West Midlands Interchange

Application Statement for Proposed Non-Material Change

West Midlands Rail Freight Interchange Order 2020 (as amended)

June 2023

Bridge No. 1 (as consented)

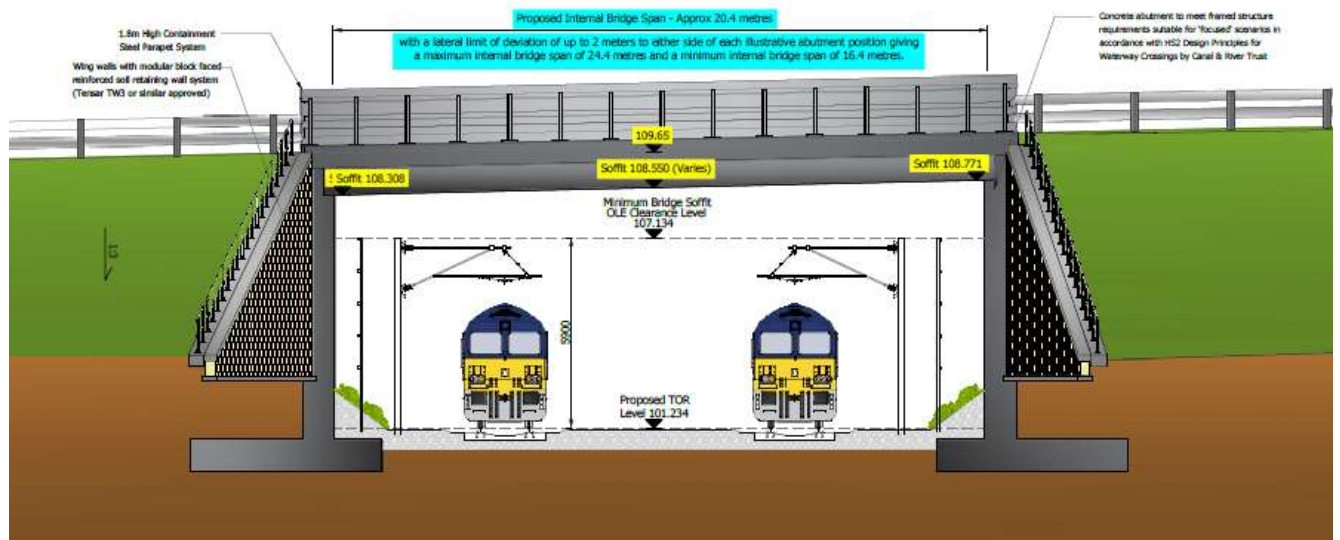
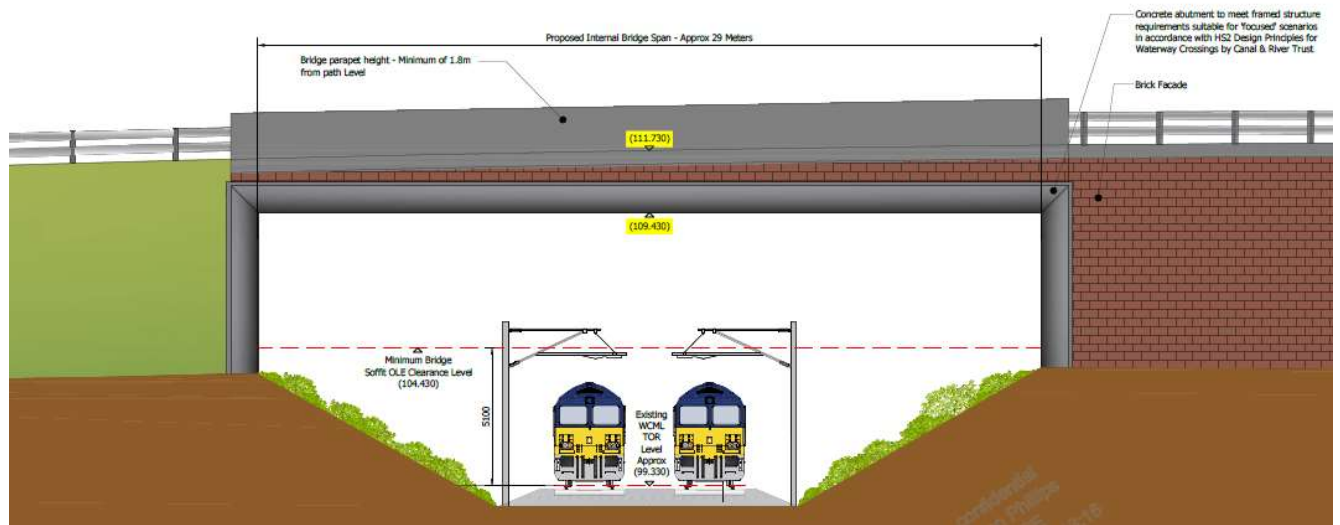
12. The proposed amendments seek to make the following amendments to the proposed internal bridge spans identified on the Bridge Plans:
 - **Bridge No.1** – increasing from approximately 8.5 metres to 20.4 metres;

32. The 2.1 metre reduction in span, together with the defined limits of lateral deviation to the bridge abutment locations and internal span width, is proposed further to discussions with Canal and River Trust ('CRT') to provide for an option where the east bridge abutment in that area could be moved closer to the Staffordshire and Worcestershire Canal, subject to agreement with the CRT. The changes provide flexibility to potentially reduce or remove space between the eastern boundary of the canal and the eastern abutment, which is currently consented, thereby removing an opportunity for and to deter anti-social behaviour and graffiti in this area.
33. The width of Bridge No.4 does not require alteration because the current width is sufficient.

Bridge No. 2 (as consented)

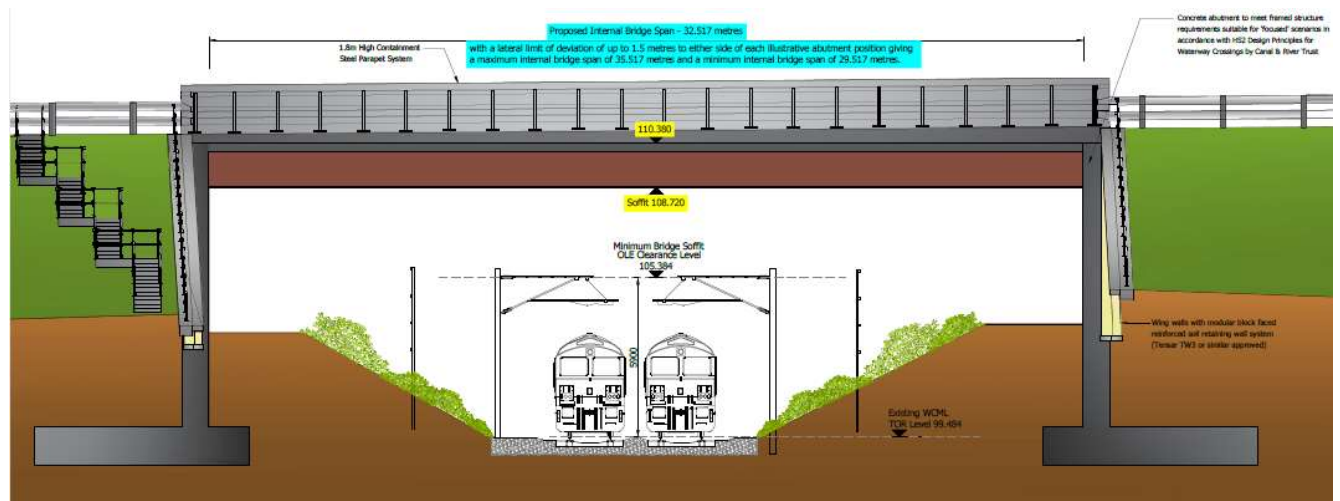
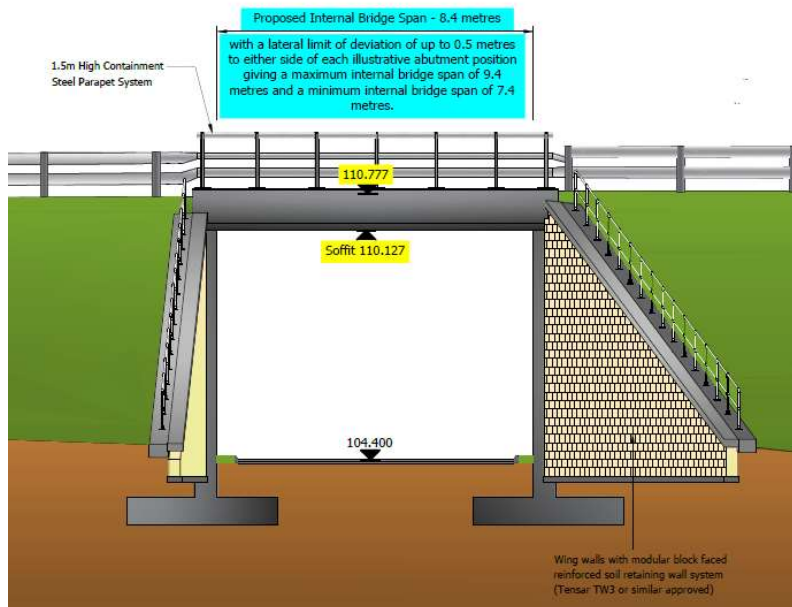
- **Bridge No.3** – width reduced by approximately 1.9 metres.
21. This reduction in width would be achieved through the following amendments to the certified Highway General Arrangement Plans (Certified Document Nos. 2.9 [Key Plan / Highway Masterplan] (Drawing No. WSP-70001979-GA-100 Rev L), and 2.9D [General Arrangement Plan 104] (Drawing No. WSP-70001979-GA-104 Rev L)).

- Increasing the width of the footway/cycleway by 0.5 metres to a width of 3.5 metres to compensate for the removal of verge; and,
 - Reduction of verge width to the south of the A5/A449 Link Road from 2 metres to 0.6 metres at the location of Bridge Nos. 2 and 3, and from 2 metres to approximately 1.4 metres at the location of Bridge No. 1.
22. The location and nature of the proposed bridge changes is shown on the plan and drawing extracts included at **Appendix B**.

Bridge No. 4 (as consented)

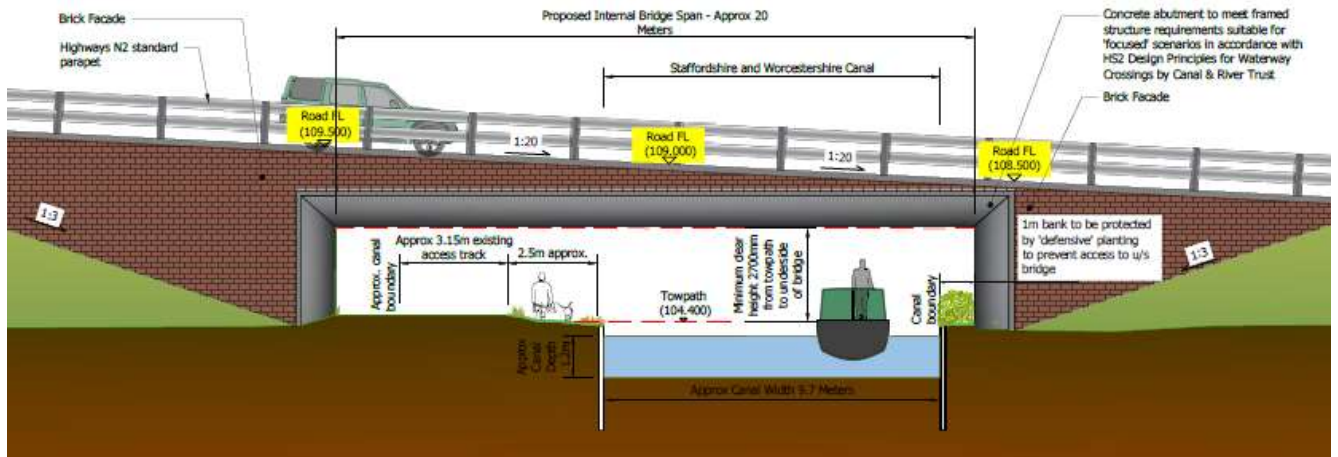
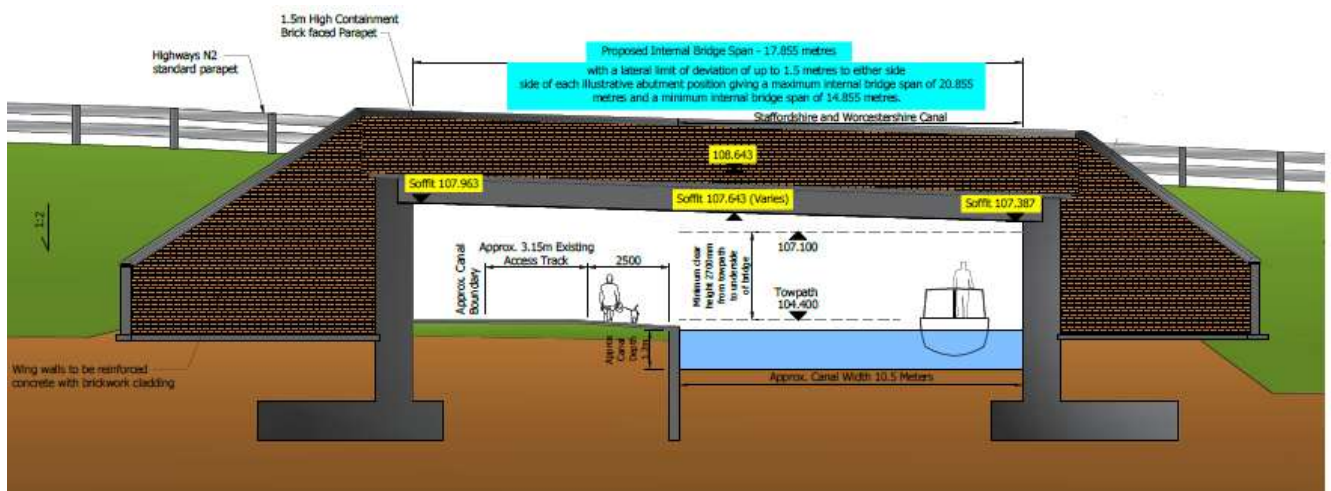
- **Bridge No.4** – reducing from approximately 20 metres to 17.855 metres.
13. In order to provide sufficient flexibility to accommodate any further detailed design development, it is proposed that the bridge plans allow for the following horizontal limits of deviation to abutment positions and associated internal bridge spans (as annotated on the proposed bridge plans):

Road height changes (as now proposed)

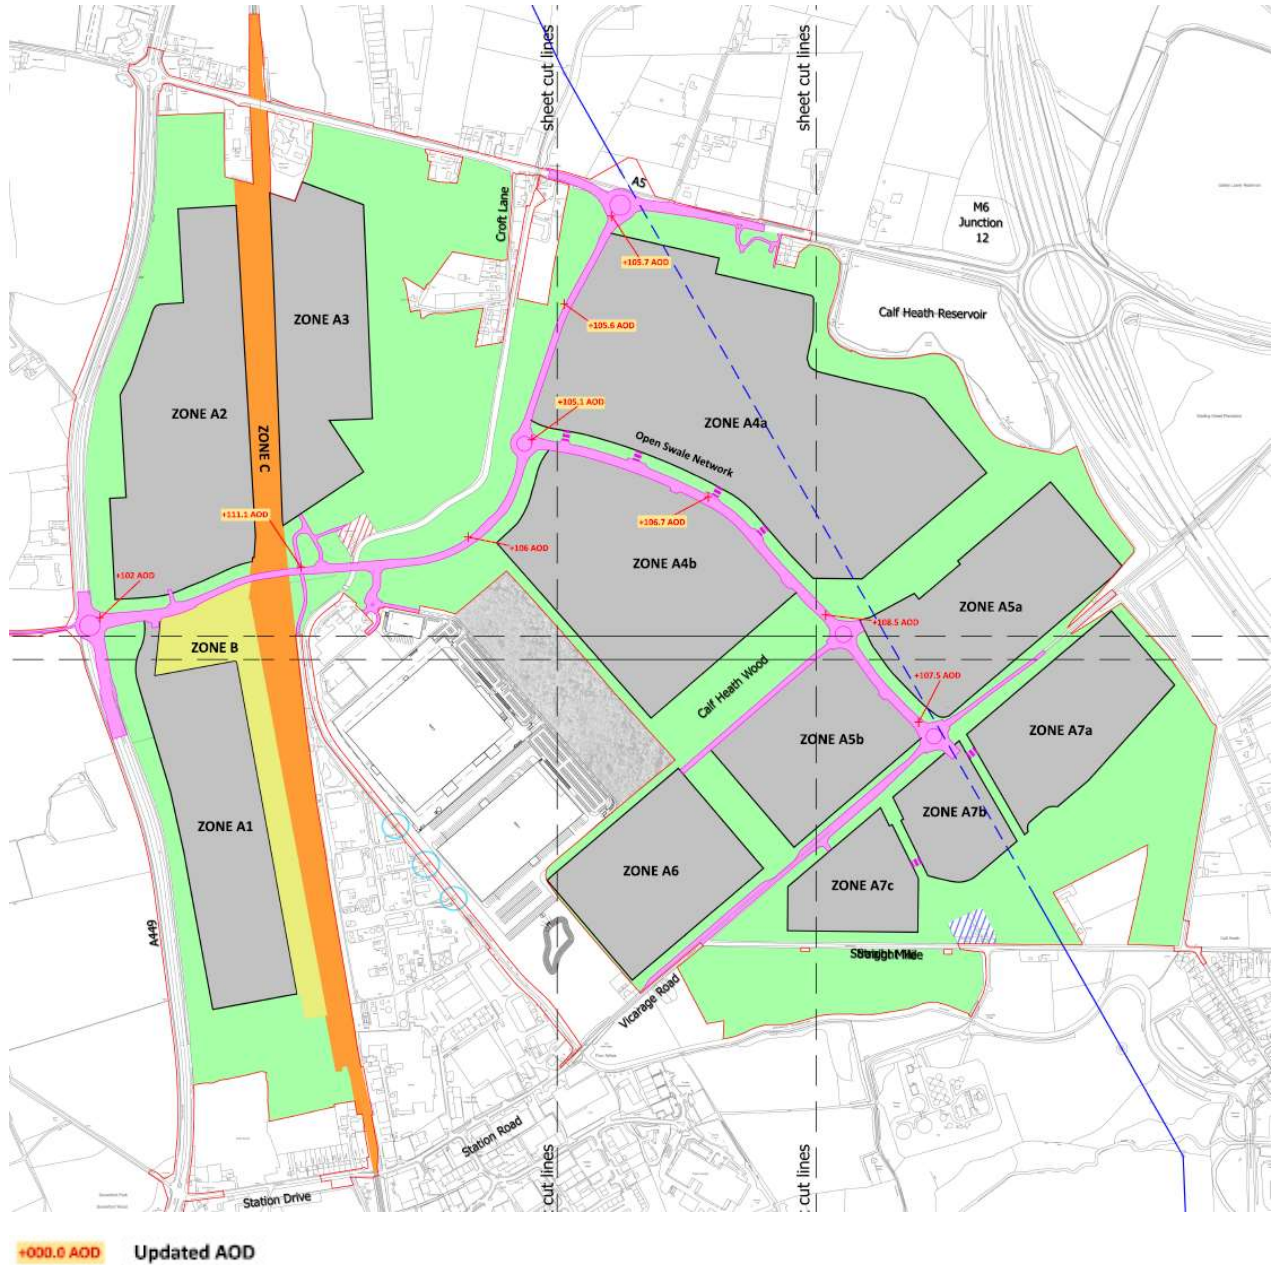
42. The maximum changes range from changing the approved spot levels by between a circa. 0.9 metres reduction and a circa. 1.2 metres increase.
43. In order to provide flexibility, it is also proposed to retain the 0.5 metre vertical (upward and downward) limit of deviation as currently provided for on the certified Development Zone, Floor Levels and Building Heights, and Green Infrastructure Parameters Plans. As set out in paragraph 39 and Section 6 of this Statement, a corresponding amendment has been made to Article 4(a) of the Order to give effect to the 0.5 metre vertical (upward and downward) limit of deviation provided for on the certified Development Zone, Floor Levels and Building Heights, and Green Infrastructure Parameters Plans.

- Reducing the finished bridge deck level on Bridge No. 3 over the proposed road access into the proposed rail terminal and rail-served warehousing (defined as Zones B and A1 on the Development Zone Parameters Plan), and similarly reducing the finished deck levels of other proposed bridges in this location, in order to provide a compliant vertical road alignment. This necessitates a change in the spot height shown in this location on the above-named parameter plans (0.9 metres downwards compared with spot height currently shown). This change in height would however comply with + 0.5 metre upwards / - 1.0 metre downward limits of deviation allowed in respect of the levels shown highlighted in yellow on the Bridge Plans permitted by virtue of Part 2, Article 4 (b) of the Order.

- Due to the increase in the finished site level of the A5/A449 Link Road on the approach to the proposed A5 roundabout in order to accommodate the required culvert underneath, the finished site level of the A5/A449 Link Road has been lowered at the midpoint between the proposed A5 Roundabout and the internal site roundabout to provide a compliant road alignment.

Extension of Zone C to south of Rail Terminal for Buffer Stops (as consented)

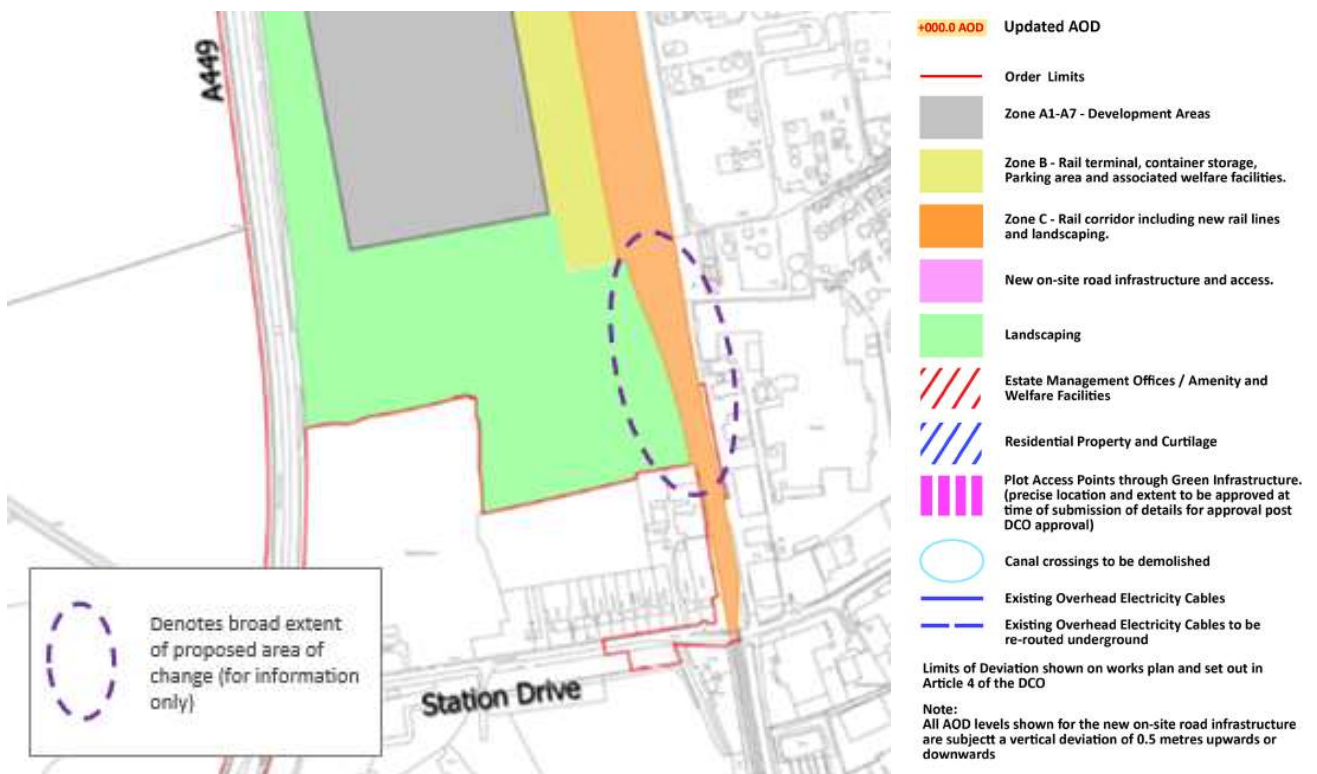
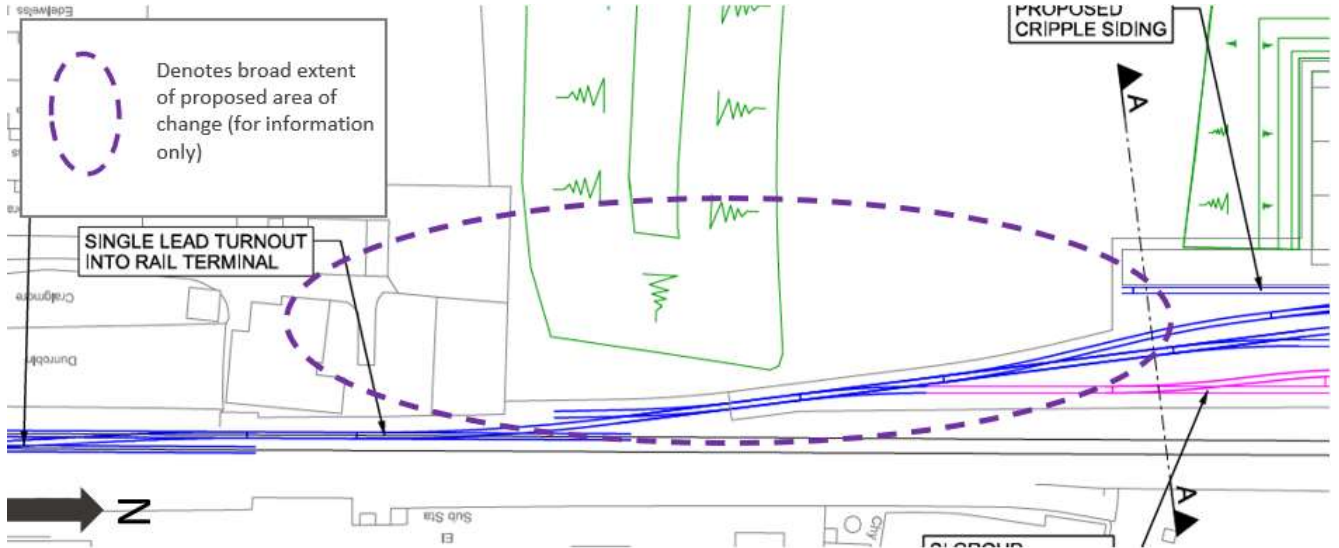
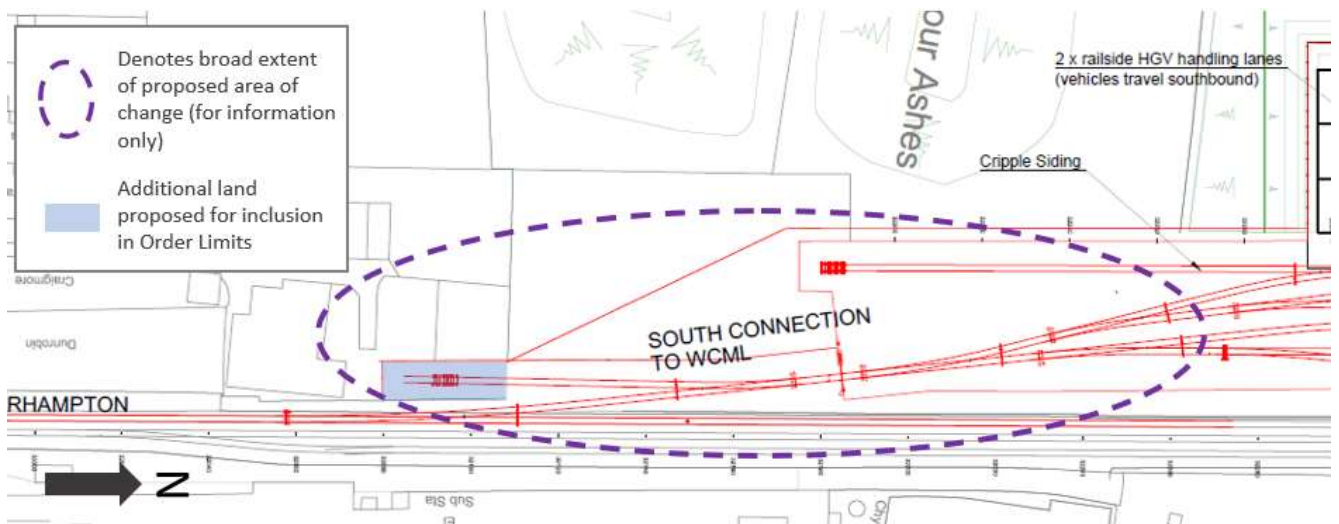
57. The Applicant requires additional land to be incorporated into the southern part of Zone C (Works No.1), comprising 2,797 sqm / 0.2797 ha. This would result in a net reduction in area identified as Landscaping (Works No. 6) land on the certified Development Zone and Green Infrastructure Parameters Plans by 2489 sqm / 0.2489

58. This would therefore bring 308 sqm / 0.0308 ha of land new land into the Order Limits (FAL own this new land and no changes to the powers of acquisition set out in the Order, or changes to the Book of Reference and certified Land Plans, are sought or needed). The Illustrative Expanded Rail Terminal Layout drawing would be altered to reflect the following amendments:
- The Cripple Siding Buffer Stop – proposed to be extended circa. 70.2 metres further southward compared with the current proposed location.
 - The Neck Shunt Trap Buffer Stop –proposed to be extended circa. 34.7m further southward compared with the current proposed location.

64. This has been identified as necessary owing to detailed design development since the grant of consent for the Order:
- At Order stage, breaking distance calculations were not carried out as design was not sufficiently advanced at that time to undertake this. The Applicant has since calculated the breaking distances within the Rail Infrastructure Area (Zone C) required for RFI operational and safety reasons as well as considering the train speeds on the WCML Loop railway, as part of the Network Rail network change process. These calculations determine the positioning of signals, which has necessitated greater setback distances between the siding standages (e.g. the Cripple Siding Buffer Stop and Neck Shunt Buffer Stop changes) from signals and positioning of axle counters⁹;

- To adequately accommodate an industry standard cripple wagon (an F series container flat wagon twin which is 40.5m long); and,
 - To provide Network Rail's Road Rail Access Point (an installation of solid panels across railway tracks enabling plant and machinery to travel over tracks) clear of the adjacent line and clearance point at the same time.
